Author's Response to Comments

We thank the reviewers for their thoughtful comments. We have prepared a revised version of the manuscript based on these comments. Replies to individual comments have been posted to EGUsphere and are included below.

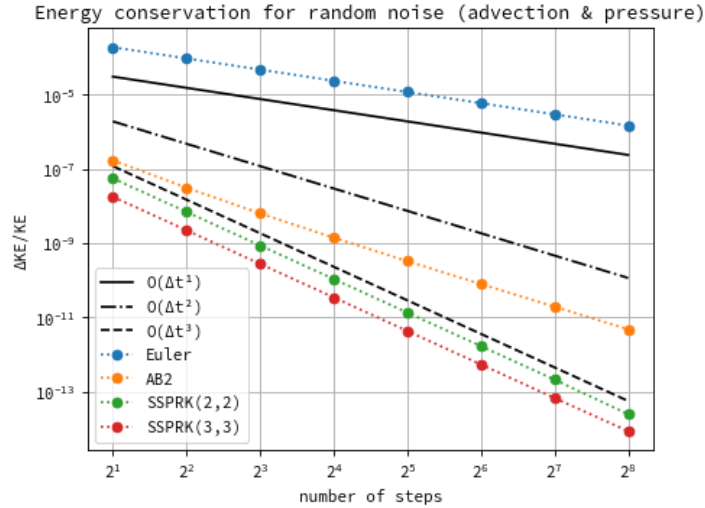
l. 147: The commutation of operators precludes their linearity; the truncation is, however, non-linear such that, in their discrete representation, the operators do not commute. The choice might impact on stability and conditioning properties of the algorithm and needs to be motivated / detailed here.

I am not sure if I understood the reviewer’s concern correctly, especially the statement “the commutation of operators precludes their linearity”, but I hope the following explanations address any doubts.

The commutativity properties we rely on apply to the discrete operators and are exact to floating-point precision. Computing vertical derivatives in the physical domain as opposed to the frequency domain can sometimes be used to reduce the number of necessary FFTs, but it should not affect the results any more than the other ways floating-point math is inexact (e.g. non-associativity of addition).

The claim that vertical derivatives commute with horizontal FFTs (forward and backward) corresponds to the Julia expression `rfft(diff(x, dims = 3), (1, 2)) ≈ diff(rfft(x, (1, 2)), dims = 3)`, which can be verified with e.g. `x = rand(8, 8, 8)` (and similarly for inverse transforms). If there are non-zero contributions from the boundary conditions, these have to be transformed as well of course, but they should not affect the commutativity of the operations.

If the truncation that the reviewer is concerned about is when the high-wavenumber contributions are discarded, we do actually rely on the fact that this operation also commutes with the vertical derivatives, although we could just as easily always do the vertical derivatives before the truncation. This commutativity is also exact and does not even have floating-point errors (e.g. `diff(x[1:3,1:3,:], dims = 3) == diff(x, dims = 3)[1:3,1:3,:]` for `x = rfft(rand(8, 8, 8), (1, 2))`). It also happens to be a linear operation, although that alone neither guarantees nor precludes commutativity. Both linear and non-linear operations can be commutative (trivially with themselves or with the identity function) or non-commutative (e.g. two matrix–vector multiplications with random matrix coefficients).
